REMARKS / ARGUMENTS

Claims 1-15, 17-30 and 32-36 are pending in the application and stand rejected. Of the pending claims, Applicant has canceled Claims 3, 4, 14, 15, 19, 20 and 30, and amended Claims 1, 17, 32, 33 and 35, leaving Claims 1, 2, 5-13, 17-18, 21-29, and 32-36, for consideration upon entry of the present Amendment.

FIG. 4B

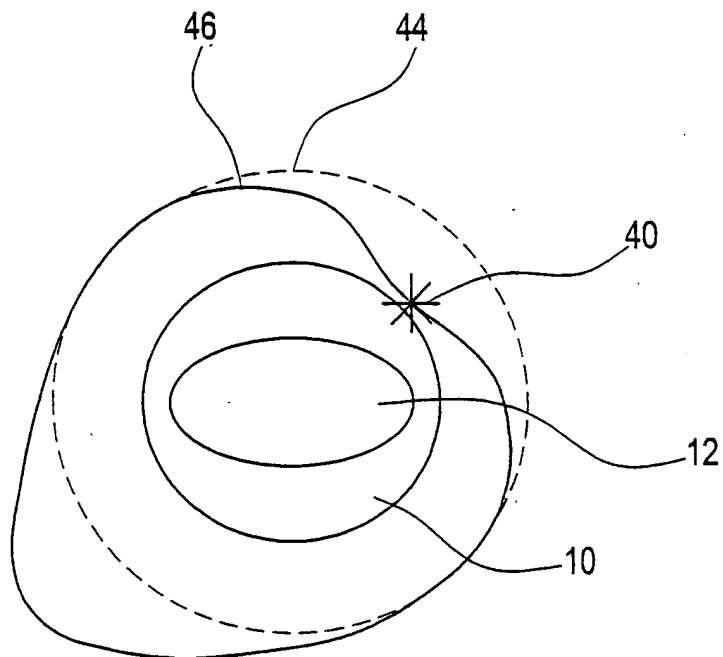
Applicant has amended independent Claim 1 to include the element of the “...***wherein said operating the imaging system comprises operating the imaging system adapted to provide said angular radiation distribution comprising a first angular radiation distribution suitable for a 360 degree image reconstruction and a second angular radiation distribution suitable for a 180 degree image reconstruction; wherein said first angular radiation distribution has a first average radiation distribution, said second angular radiation distribution has a second average radiation distribution, and said first and second average radiation distributions are about constant throughout said scan.***” (emphasis added), which finds support in the specification as originally filed at paragraphs [0030-0032] and Figures 4B and 5.

Here, Applicant claims a method for reducing radiation exposure that includes the operation of an imaging system, where the imaging system is adapted for 360 degree image reconstruction and 180 degree image reconstruction, and where the average radiation distribution 44 for each type of image reconstruction is about constant throughout a scan while allowing for the angular radiation distribution 46 to be modified. Paragraph [0032], lines 8-10, and Figure 5.
